# Access Compliance Report

## Public Rights-of-Way

### (Curb Ramps)

Intersection ID: 12912	Main Street: ENFIELD_RD	Cross Street: SUDBURY_RD	Location: SE
ADA ID: 92C652C10F6D	Ramp Type: Perp	Initial Pass/Fail: Fail	Overall Compliance: No
		Severity Score: 10

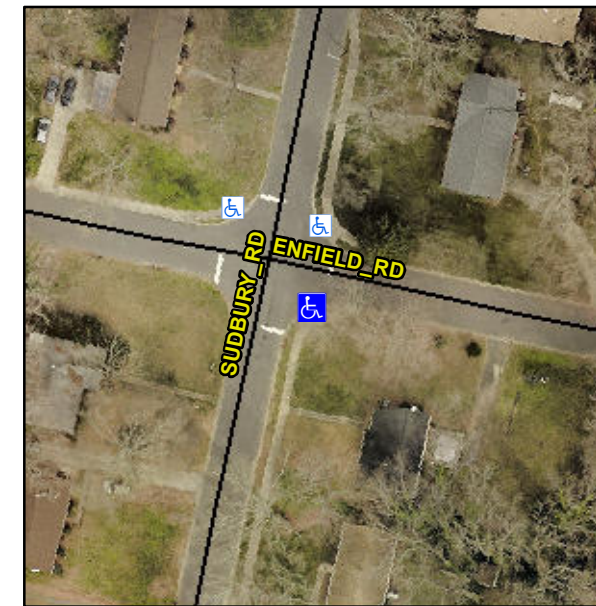
**Not Found, R304.5.1, R304.5.3**

Compliance	Description	Data	Compliance	Description	Data
N/A	Ramp Length (in)	48.0	Yes	Ramp Slope (%)	6.3
No	Ramp Width (in)	45.0	No	Ramp XSlope (%)	4.8
N/A	Flare Type LT	N/A	N/A	Flare Type RT	N/A
N/A	Flare Slope LT (%)	N/A	N/A	Flare Slope RT (%)	N/A
N/A	Flare Traversable LT?	N/A	N/A	Flare Traversable RT?	N/A
N/A	Landing Length (in)	N/A	N/A	DWS Provided?	N/A
N/A	Landing Width (in)	N/A	N/A	DWS Contrast?	N/A
N/A	Landing Slope (%)	N/A	N/A	DWS Length (in)	N/A
N/A	Landing X Slope (%)	N/A	N/A	DWS Full Width?	N/A
N/A	Landing Curb? (Y/N)	N/A	N/A	DWS Offset (in)	N/A
N/A	Shared Landing?	N/A			
N/A	Gutter Ponding?	N/A	N/A	Gutter Slope (%)	N/A
N/A	Gutter Lip Ht (in)	N/A	N/A	Gutter X Slope (%)	N/A
N/A	Painted X Walk1?	No	N/A	Painted X Walk2?	N/A
	X Walk 1 Direction	To N		X Walk 2 Direction	N/A
N/A	X Walk 1 Width (in)	N/A	N/A	X Walk 2 Width (in)	N/A
	X Walk 1 Slope (%)	1.8		X Walk 2 Slope (%)	N/A
	X Walk 1 X Slope (%)	5.5		X Walk 2 X Slope (%)	N/A

**Remove & Replace Entire Ramp.**
